Bulletin

MARCH, 1955

No. H82-G

MECHANICAL DESIGN CHANGES AND MODIFICATIONS (Engine Oil Pump, Valve Overhead Gear, Clutch Gear Spigot Bearing)

Fig. 2

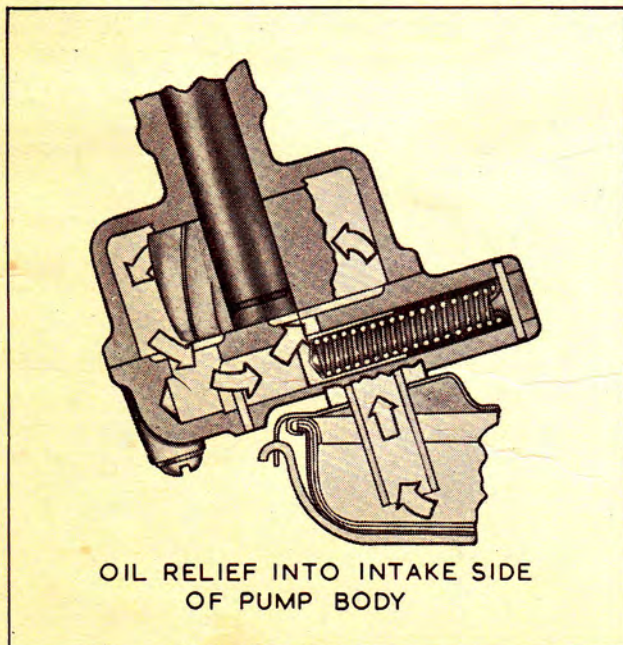
The oil pump has been re-designed to incorporate helical gears, Fig. 1, and a relief valve with an internal bypass located in the cover and so positioned that when the relief valve opens, the oil passing the valve is directed back into the intake side of the pump, Fig. 2. The helical gears provide for quieter operation, while the design of the relief valve is such that there is little possibility of the valve being held open by foreign matter.

Note: The pump body and cover mating surfaces are in direct contact; no gasket being used on this type pump.

Fig. 3

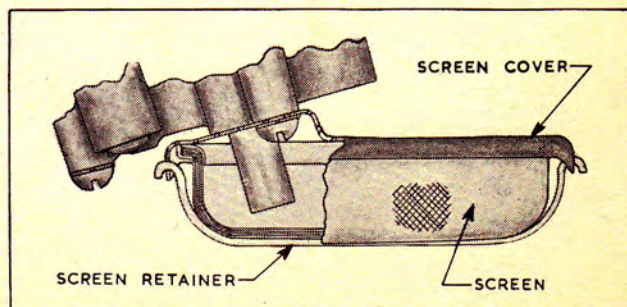
The oil pump screen and cover have also been re-designed with the object of ensuring that all the oil entering the inlet side of the pump must pass through the close woven wire screen, Fig. 3.

Fig. 4

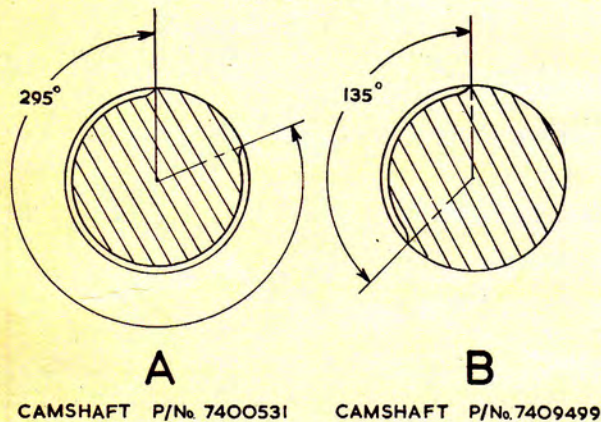
The oil distribution groove to the valve overhead gear has been reduced in length from approximately $5/6$ ths (295°) of the circumference of the rear intermediate journal, to approximately $1/3$ rd (135°) of the journal, Fig. 4.

Fig. 5

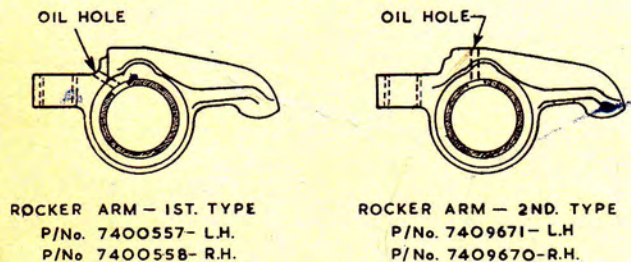
The valve rocker arms have been modified by re-positioning the oil bleed hole to allow more oil to flow to the rocker arm and valve stem contact, Fig. 5.

NOTE: The new type rocker arms should only be fitted to engines which are equipped with valve seals and the 2nd type camshaft (smaller oil groove), otherwise excessive oil consumption may be experienced due to excess oil passing down valve guides.

Fig. 6

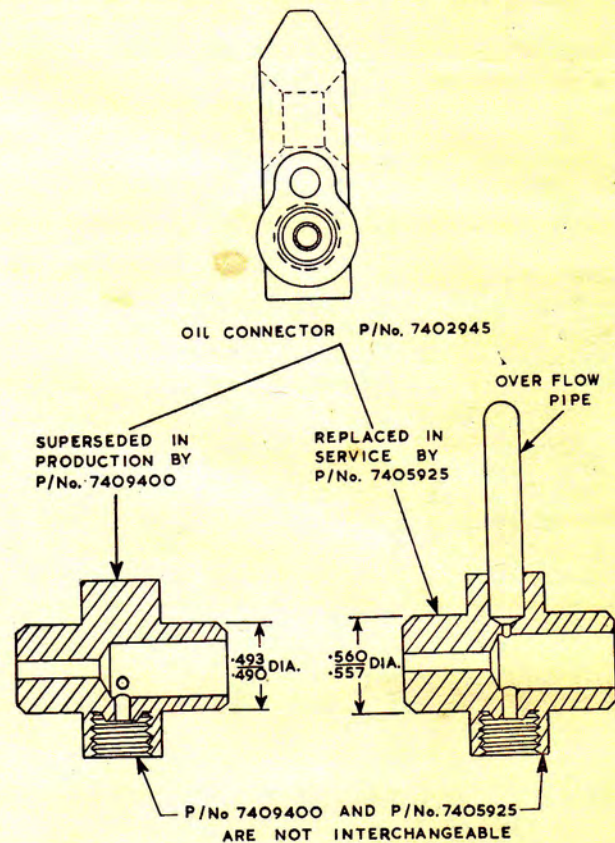
The rocker arm shaft oil connector, which bridges and distributes oil to the rocker shafts, is now of one-piece construction and so formed that its outer ends enter the inner diameter of both the front and rear shafts, Fig. 6.

Oil flowing to the rear rocker arm shaft is metered by a drilled passage in the connector.

NOTE: The oil connector must always be fitted with the small metered hole to the rear rocker arm shaft so as to ensure correct distribution of oil to the valve overhead gear.

The 2nd type oil connector is not suitable for engines prior to approximately engine No. 197338 and as the 1st type connector will not be serviced when existing stocks are exhausted, a service oil connector, Part No. 7405924, will be made available, which is of the same simplified design as the new connector but varies dimensionally to accommodate larger openings in the ends of the 1st type rocker arm shafts. The service connector is readily identified by a short oil flow return pipe fitted to the body, Fig. 6.
